**Subject:** [External\_Sender] L-2016-101 Signed 05-06-2016 Main Control Room Habitability Analysis  
**Attachments:** L-2016-101 Signed 05-06-2016 Main Control Room Habitability Analysis.pdf

Re: Florida Power & Light Company  
Proposed Turkey Point Units 6 and 7  
Docket Nos. 52-040 and 52-041  
Voluntary Submittal of Exemption Request and Design Change Description for Departure from AP1000 DCD  
Revision 19 to Address Main Control Room Habitability Analysis

Departure Number	Departure Description Summary	FSAR Section or Subsection
<b>PTN DEP 6.4-2</b>	<b>Main Control Room Heatup The following are the departures from the DCD: Tier 1 Tables 2.2.5-1, 2.2.5-4, 2.5.2-3 and 2.5.2-4, Tier 2 Table 3.7.3-1 (Sheets 1 and 2 of 3), Table 3.9-12 (Sheet 6 of 7), Table 3.9-16 (Sheet 23 of 26), Table 3.9-17, Table 3.11-1 (Sheets 17, 30 and 47 of 51), Figure 3D.5-1 (Sheet 1 of 3), Table 3I.6-2 (Sheet 11 of 28), Table 3I.6-3 (Sheets 10 and 28 of 32), Subsections 6.4.2.2, 6.4.2.3, 6.4.3.2, 6.4.4, 6.4.5.1, 6.4.5.3 and 6.4.8, Table 6.4-3, Figure 7.2-1 (Sheet 13 of 21), Subsection 7.3.1.2.17, Table 7.3-1 (Sheet 7 of 9), Table 7.3-3 (Sheet 2 of 2), Table 7.5-1 (Sheet 11 of 12), Table 7.5-7 (Sheet 4 o

20. COLA Part 2, FSAR Chapter 7, is revised to add new Figure 7.2-1R (Sheet 2 of 2) with left margin annotation PTN DEP 6.4-2 as follows (departure from DCD Figure 7.2-1 (Sheet 13 of 21))departure from DCD Figure 7.2-1 (Sheet 13 of 21)):

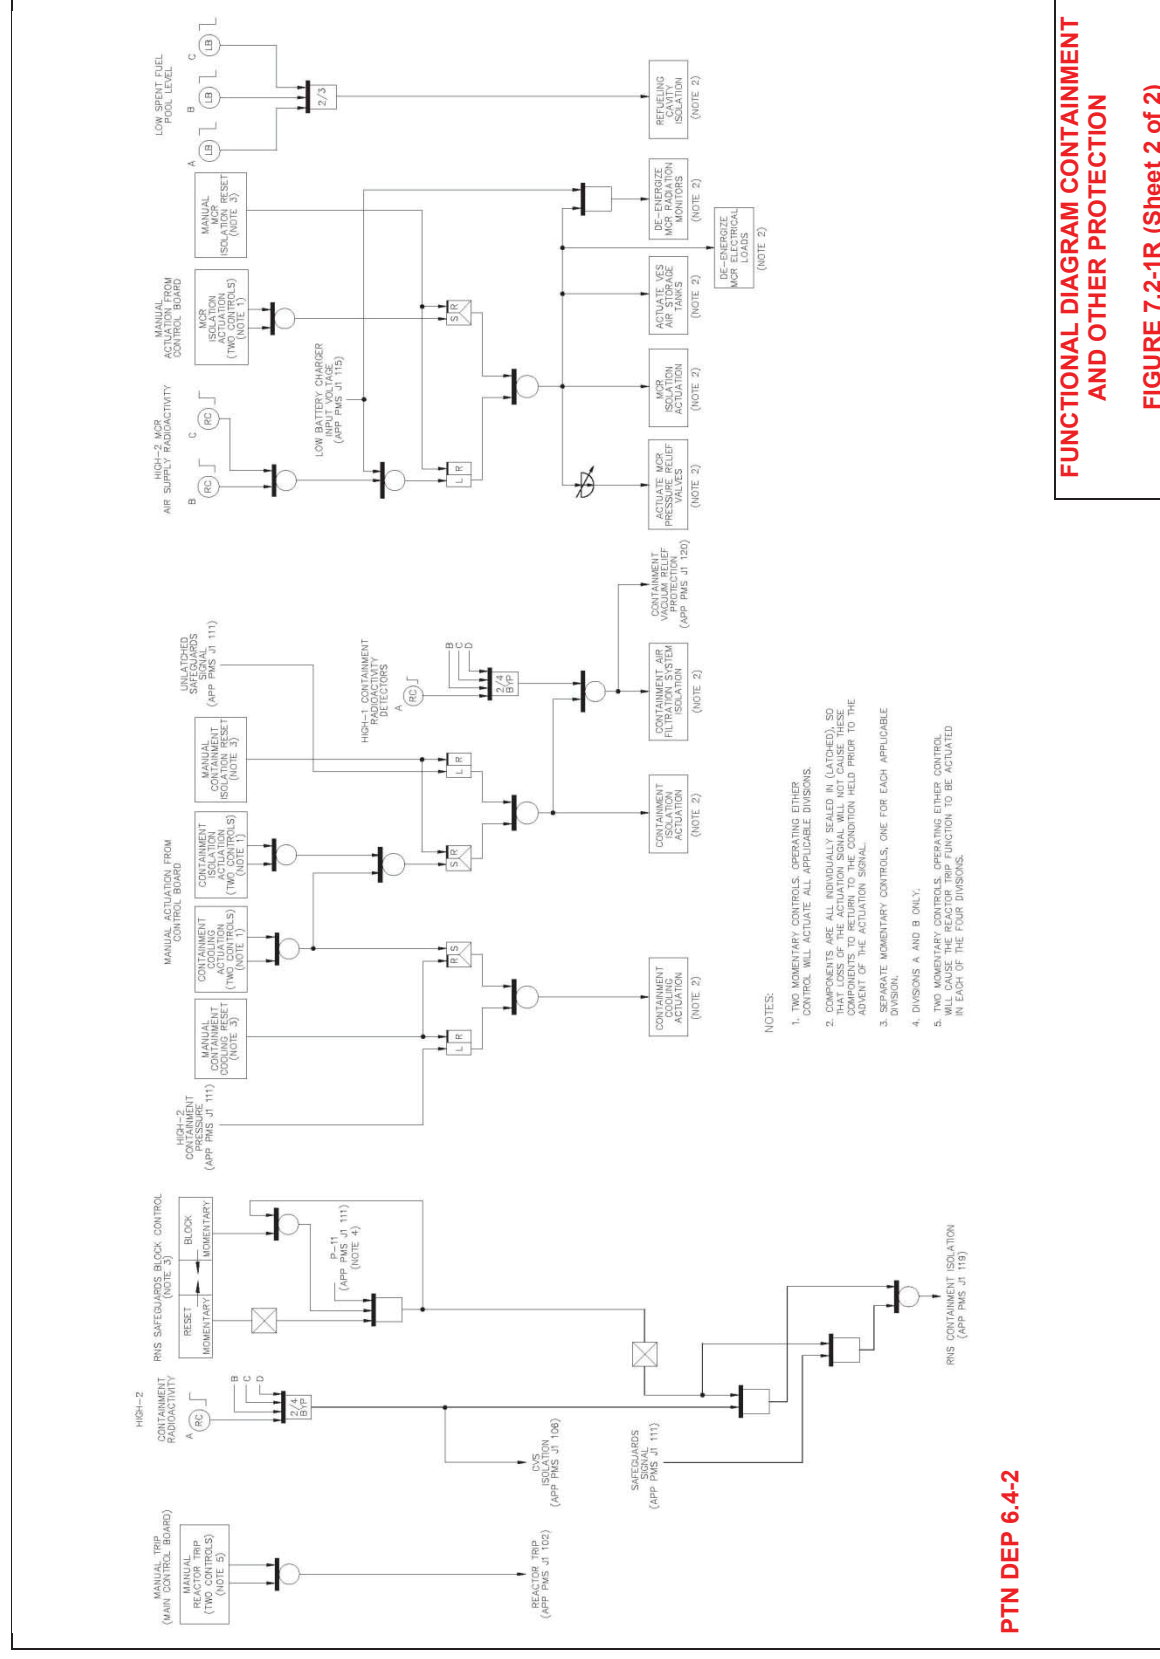
**PTN DEP 6.4-2      The functional logic relating to main control room isolation, air supply initiation, and electrical load de-energization is illustrated in Figure 7.2-1R (Sheet 2 of 2).**

Figure B 3.7.6-1  
Compressed Air Storage Tanks Minimum Volume

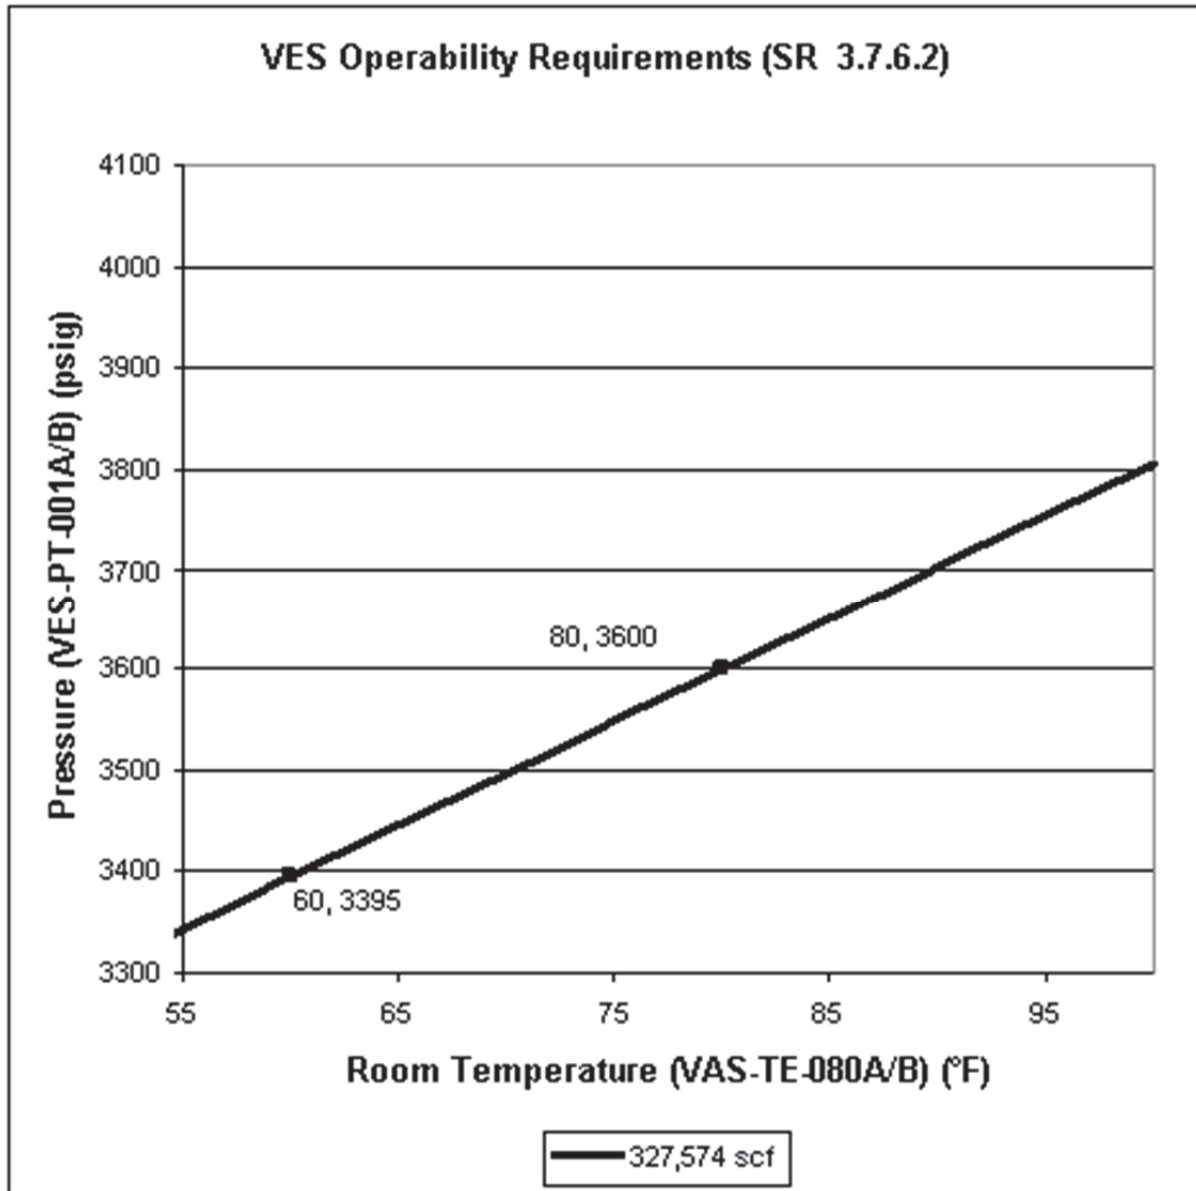
The standard volume is determined using the compressed air storage tank room temperature (VAS-TE-080A/B), compressed air storage tanks pressure (VES-PT-001A/B), and Figure B 3.7.6-1, Compressed Air Storage Tanks Minimum Volume. Values above the 327,574 scf line in the figure meet the surveillance criteria. Verification that the minimum volume of compressed air is contained in the compressed air storage tanks ensures that there will be an adequate supply of breathable air to maintain MCRE habitability for a period of 72 hours. The Frequency of 24 hours is based on the availability of pressure indication in the MCRE.

Figure B 3.7.6-2  
Compressed Air Storage Tanks Minimum Volume – One Bank of VES Air Tanks  
(8 Tanks) Inoperable

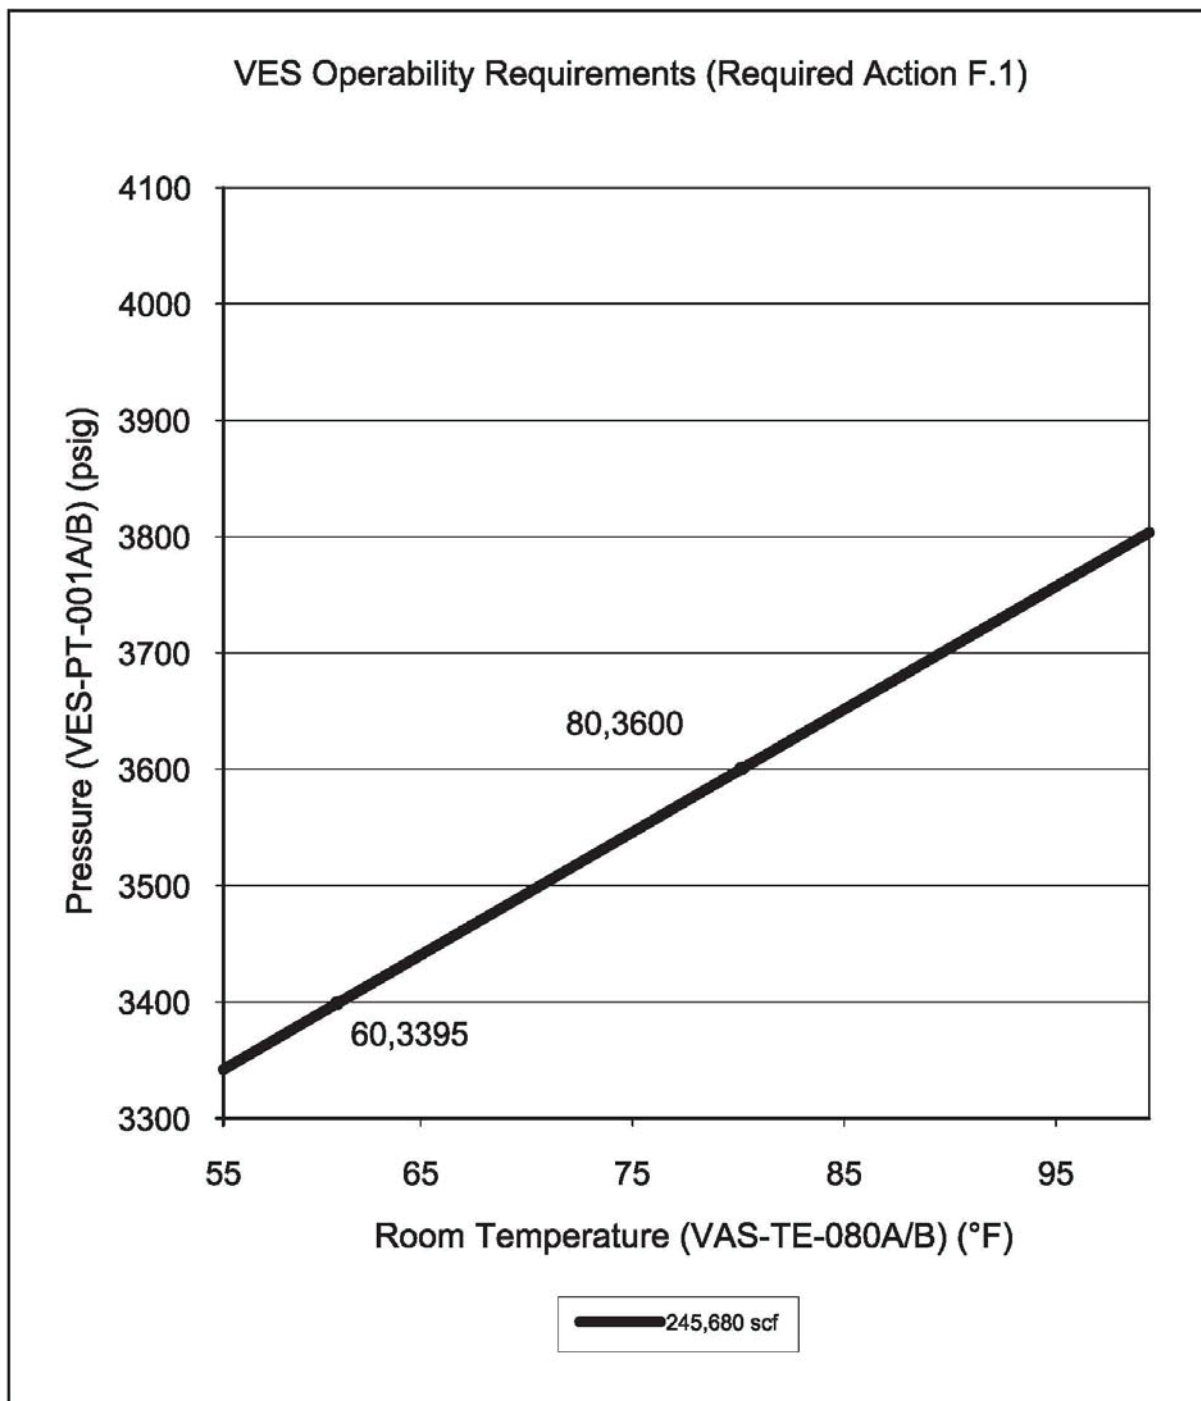
2. TS 3.7.6 for the VES will be revised to add required actions for inoperability of the MCR Load Shed Panels, for the maintenance of required air temperature limits and to ensure the quality of air in the VES storage tanks. A new TS surveillance requirement (SR) 3.7.6.3 will be added to ensure that MCRE exterior temperatures do not exceed values assumed in supporting calculations. TS SR 3.7.6.6 will be revised to ensure that the air quality in the VES storage tanks will meet its design function. In addition, periodic surveillance testing of the new electrical load shed equipment will be added as TS SR 3.7.6.12. The order that the requirements are listed was changed based on the required surveillance frequency. The existing air quality surveillance was modified to include a dew point requirement. The Bases for TS 3.7.6 will be revised accordingly.
